REMARKS/ARGUMENTS

Objection to the Drawings

Amendments to the Drawings:

Annotated Sheet Showing Addition of Figs. 18-21

FIG 18

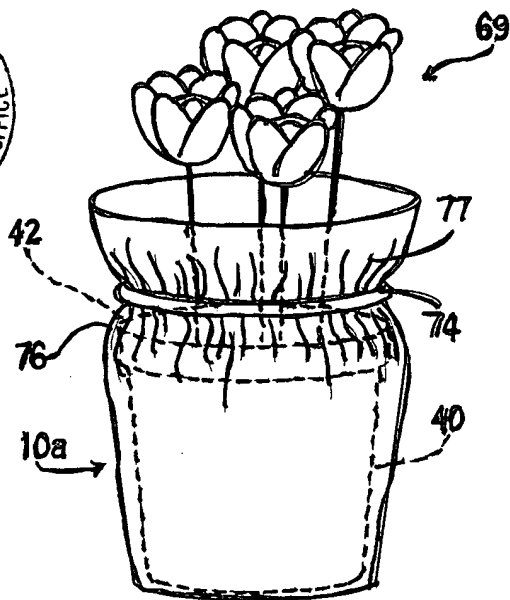
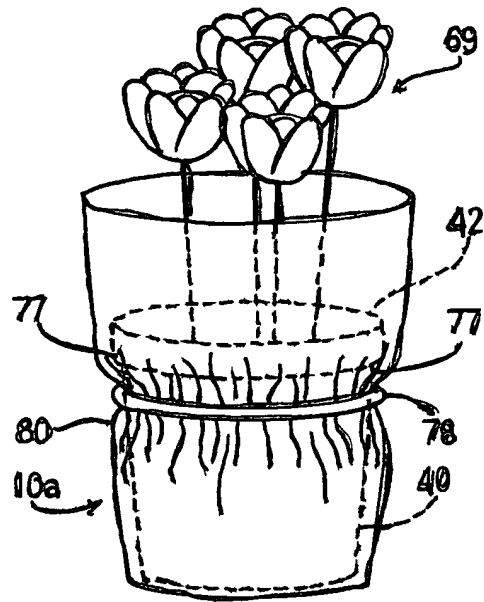
"The tapered shaped sleeve having a banding element as cited in instant independent claims 1 and 16 are not depicted (the sleeves depicted in Figures 14-17 are not tapered), and the embodiment of instant independent claims 1 and 16 are not depicted as further limited by instant dependent claims 8 and 22 respectively (tapered sleeve having a side gusset)."

In response to the objection, new Figures 18-21 have been added. Figures 18 and 19 show a tapered sleeve 10a which is secured about a pot via a securing element, and Figures 20 and 21 show a tapered and side-gusseted sleeve 10b which is secured about a pot. Sleeves 10a and 10b are supported and enabled in the original specification in paragraphs [0028] - [0030] and Figures 7-9. Further, paragraph [0037] states that any of the sleeves described in the specification (including 10a and 10b) can be secured about a pot. Therefore, Applicant respectfully submits that Figs. 18-21 are fully enabled in the specification as originally filed and do not constitute new matter.

The specification has been amended in accordance with the new Figures. In particular, new paragraphs [0020a] - [0020d] and [0039a] and [0039b] have been added. Again, Applicant respectfully submits that newly added paragraphs [0020a] - [0020d] and [0039a] and [0039b] are fully enabled in the specification as originally filed thus do not constitute new matter. Applicant respectfully requests that the amendments to the specification and drawings be entered into the record. Applicant also respectfully requests reconsideration and withdrawal of the objection.
